# 27 Addison Street, Shellharbour

# BCA Assessment Report Report 2024/0668 R1.1

Prepared for Indiegre PTY LTD July 2024

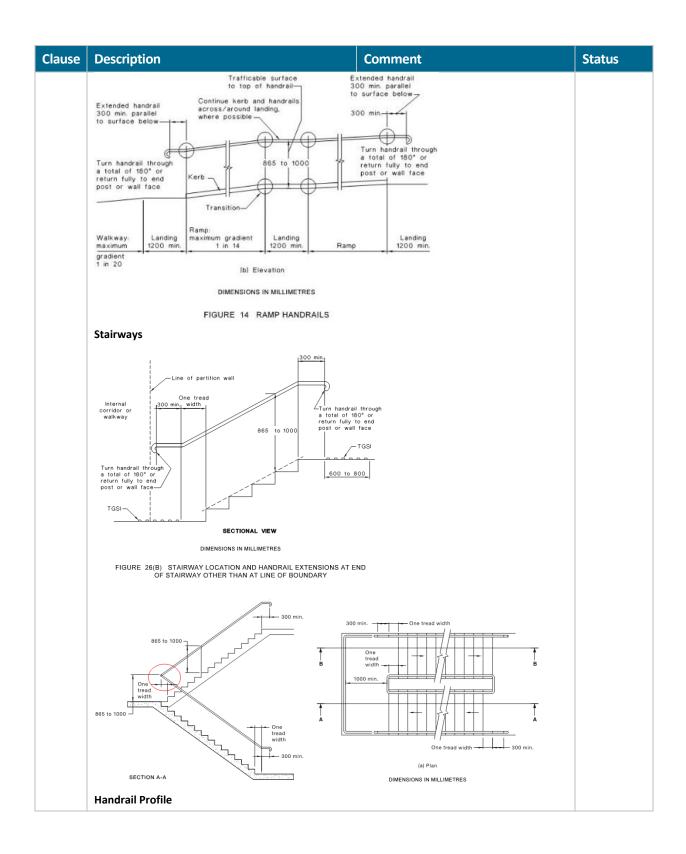
(b) A horizontal exit or a fire-isolated passageway leading to a horizontal exit.	
		Open space: A space on the allotment, or a roof or similar part of a building adequately protected from fire, open to the sky and connected directly with a public road.	
		The client has advised that a Fire Engineer should be engaged at CC stage to address variations to the DtS requirements.	
D2D4	When fire-isolated stairways and ramps are required	The stairs serving basement level have been designed as fire isolated stairs.	Complies
	Every stair in a Class 2 building must be fire isolated unless it does not connect or pass through more than 4 consecutive floors in a sprinkler protected building, or 3 storeys in a non-sprinkler protected building.	The stair serving Level 1-3 does not connect more than 3 storeys.	
D2D5	Exit travel distances  The BCA limits maximum travel distances to a point of choice and to an exit.	The distance to an exit exceeds the prescriptive requirements of the BCA in the following locations;	Performance Solution

No point on the floor must be more than 20m to an exit or a point in which travel in different directions to 2 exits is available, in which case, the maximum distance to 1 exit cannot exceed 40m.	1. Level 1- 16m to an exit
